COMMUNITY DEVELOPMENT DEPARTMENT REPORT

SUBJECT: Rackham Microhospital CUP, MDA, PP
H-2026-0011

LOCATION: 3330 and 3376 E. Overland Road, located in the Southwest ¼ of the Southwest Corner of Section 16, Township 3N, Range 1E, Parcel No(s) S1116336421, S1116336403 and S1116336453

5 PLANT SPACING DIAGRAM
1" = 10'

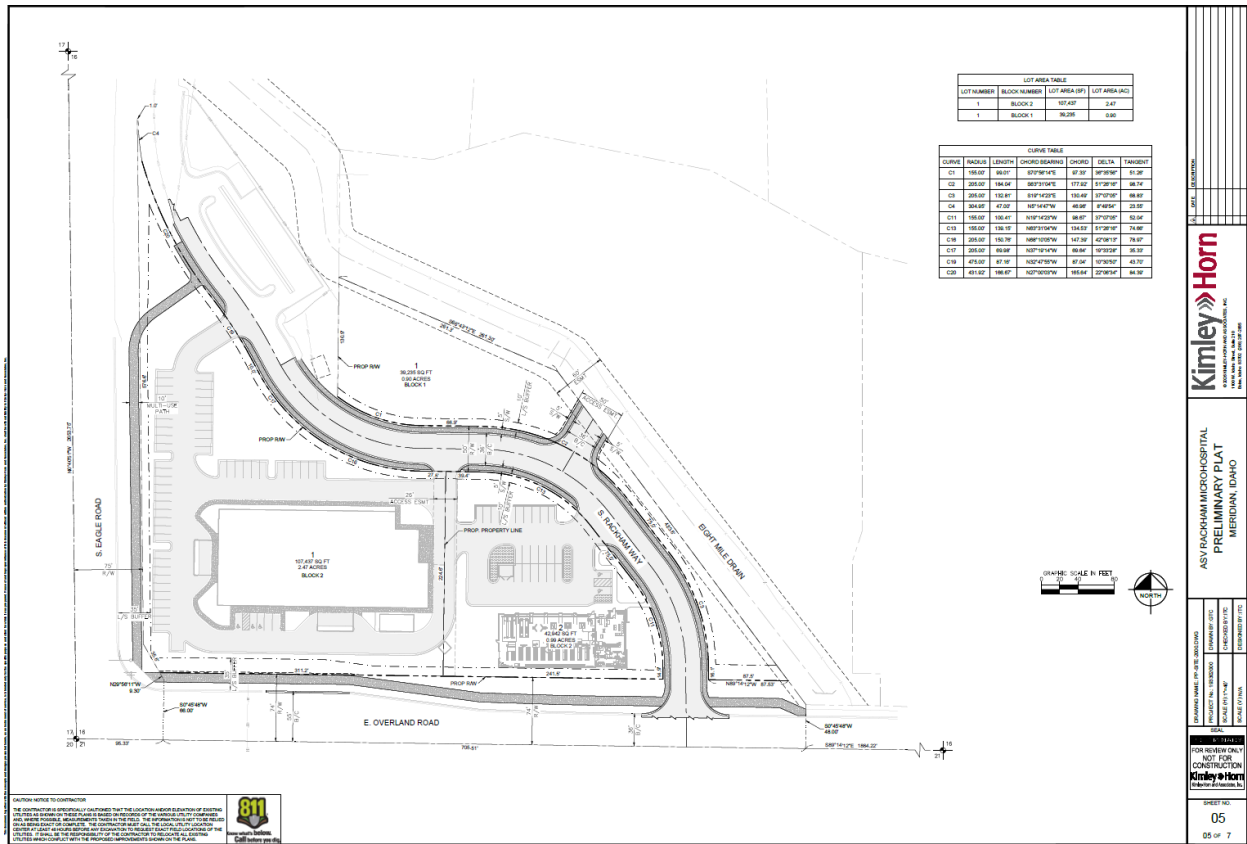
5. The landscape plan prepared by Christopher M. Rose, Landscape Architect; dated July 2, 2026 shall be revised as follows:
 - a. Show the six (6) foot high open vision fence along Eightmile Creek outside the easement.

- b. Provide the dimension for the 8-foot wide landscape strip between the existing back-of-curb and the street edge of sidewalk along E. Overland Road per ACHD requirement.

- c. Provide an internal pedestrian pathway shall be provided from the sidewalk. The internal pedestrian walkway shall be distinguished from the vehicular driving surfaces through the use of pavers, colored or scored concrete, or bricks.

- d. Provide additional landscaping along both sides of the pathway on the northwest side of the property leading up to Racham Way that meets the requirements of UDC 11-3B-12 Pathway Landscaping.

E. Preliminary Plat (date: 6/15/2026)

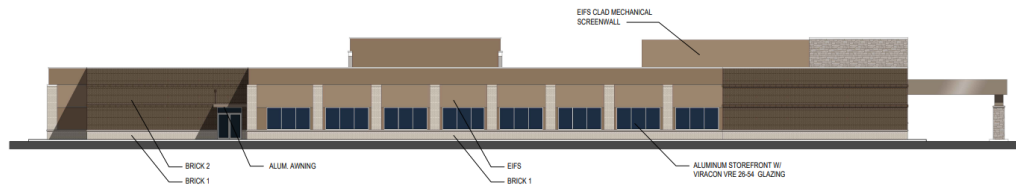
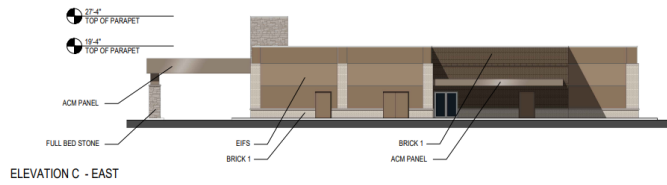
- ~~2. Complete the vacation/exchange prior to submittal of the first final plat.~~
3. No building permits shall be issued prior to ~~issued until the plat has been recorded and the existing Rackham Way right-of-way has been vacated to establish the new roadway.~~ The plat shall be recorded prior to Certificate of Occupancy for the first building permit

4. If the existing segment of Rackham Way that is proposed to be vacated/ exchanged is not approved, redesign the site and resubmit a revised preliminary plat for review. At a minimum, per ACHD, improve the west side of Rackham Way abutting the entire site as a complete 36-foot wide commercial street section with vertical curb, gutter, and a minimum 5-foot wide concrete sidewalk.
